# UNITED STATES PATENT AND TRADEMARK OFFICE

| 10/809,768  | 03/24/2004  | Ralph Fritz Zwirrmann | 060960-5014-US                 | 7926             |

## Office Action Summary

## DETAILED ACTION

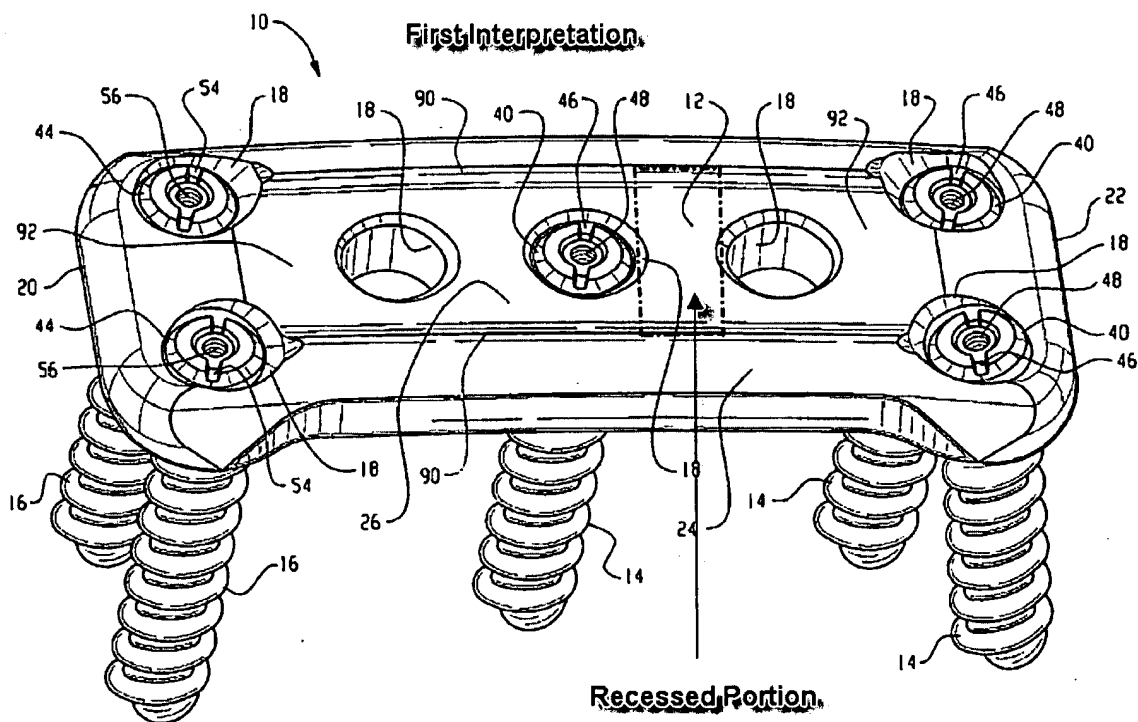
Claims 1-3, 11-13, 16, 17 and 50 are rejected under 35 U.S.C. 102(b) as being anticipated by Eisermann et al (US Patent 6,342,055).

Eisermann et al disclose a an straight elongate bone plate (**Figure 1**) comprising: a top surface (**90**); a bottom bone-contacting surface (**28**); two countersunk fastener holes (**18**); the countersunk holes having a first inclined wall (**34**) and a second inclined wall (**36**); and the corner of the plate between edge (**24**) and top surface (**90**) is chamfered (see **Figure 5**).

**[First Interpretation Shown Below]**

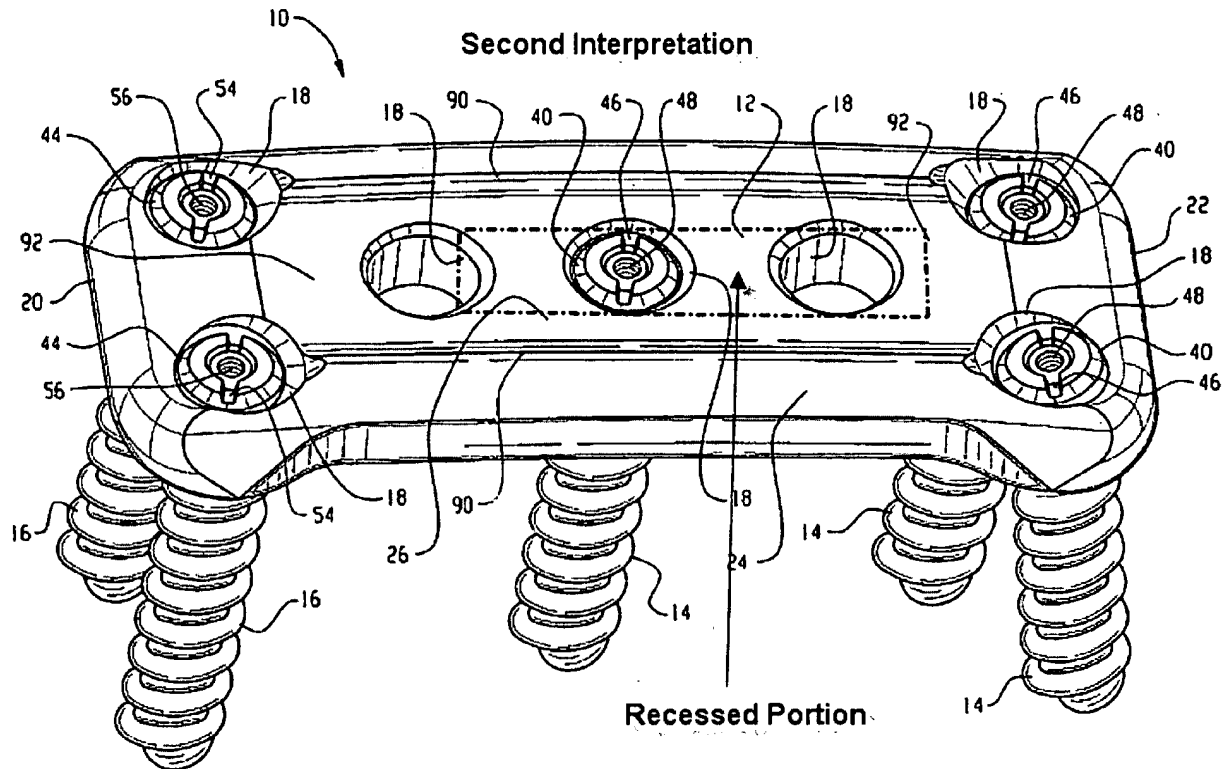
Eisermann et al further disclose a "recessed **region**" in the top surface (**90**):

The recessed portion/region has a width no more than a diameter of a countersunk hole (**18**); intersects both countersunk holes (**18**); and has a shape selected from the group of V-shaped, concave-shaped, and U-shaped.
